World Forum for Harmonization of Vehicle Regulations**Working Party on Passive Safety****Seventieth session**

UN Regulation No. 16 (Safety-belts)**Proposal for the 09 series of amendments to UN Regulation
No. 16 (Safety-belts)****Submitted by the experts from Japan***

The text reproduced below was prepared by the expert from Japan. It describes the new requirements concerning the safety-belts of seat positions equipped with the lower ISOFIX anchorage. It is based on informal document GRSP-69-23 distributed during the sixty-ninth session of the Working Party on Passive Safety (GRSP). The modifications to the current text of the UN Regulation are marked in bold for new characters.

Figure 2.
Photo of the buckle strap path when not straight

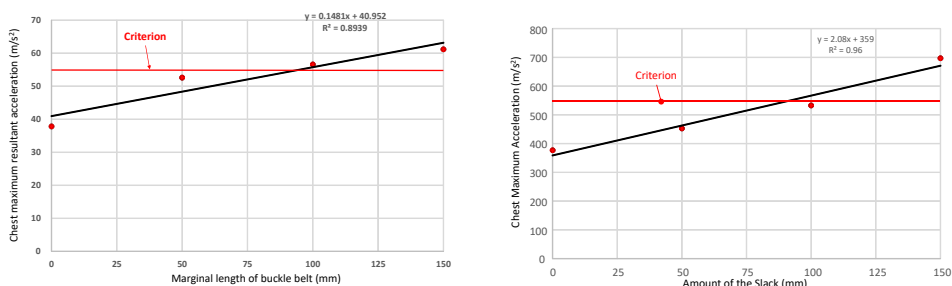
1. The strap's paths between the effective belt anchorage and the buckle are normally straight like the test bench specified in UN Regulation No. 129 (Figure 1). However, the strap's paths between the effective belt anchorage and the buckle of some vehicles in the market are not straight, and are curved along the cushion (Figure 2).

2. When the strap’s paths between the effective belt anchorage and the buckle are not straight, the occupants may move significantly forward during a frontal impact accident. If an occupant is seated in the booster seat attached by ISOFIX, there are cases in which the seatbelt slips up to the neck and in which submarining occurs (referred to in GRSP-69-24). These phenomena would increase the risk to the neck and abdomen of a child occupant. In addition, the dummy chest injury increases. Figure 3 shows the relation between the amount of slack of the buckle strap and dummy 3ms chest maximum acceleration for two types of CRS. When the slack of the buckle belt was over [50] mm, the chest maximum acceleration approached UN Regulation No. 129 criteria in one CRS. When the slack of the buckle belt was over [80] mm, the chest maximum acceleration exceeded the R129 criteria.

- "8.2.3. **The requirement of the strap between the buckle and effective belt anchorage at seats equipped with ISOFIX lower anchorages."**
- 8.2.3.1. **The difference between the actual strap length and the straight line distance between the effective belt anchorage and BP point for the buckle strap, according to paragraph 3.2. of Annex 17 Appendix 1, should be [50] mm or less."**

- 8.2.3.2. **In the case that the path of the strap between the buckle and effective belt anchorage is defined by a rigid part whose shape is not deformed during the dynamic test specified in UN Regulation No. 94 or No. 137, and the manufacturer shows those data and the technical service confirms those data, paragraph 8.2.3.1. does not apply."**

- 8.2.3.3. **In the case that the path of the strap between the buckle and effective belt anchorage is not straight during the dynamic test specified in UN Regulation No. 94 or No. 137, and the manufacturer shows the length of the strap between the buckle and effective belt anchorage during the dynamic test and technical service confirms that length, the difference between the actual strap length and the path length during the dynamic test between the effective belt anchorage and BP point for the buckle strap, according to paragraph 3.2. of Annex 17 Appendix 1, should be [50] mm or less."**
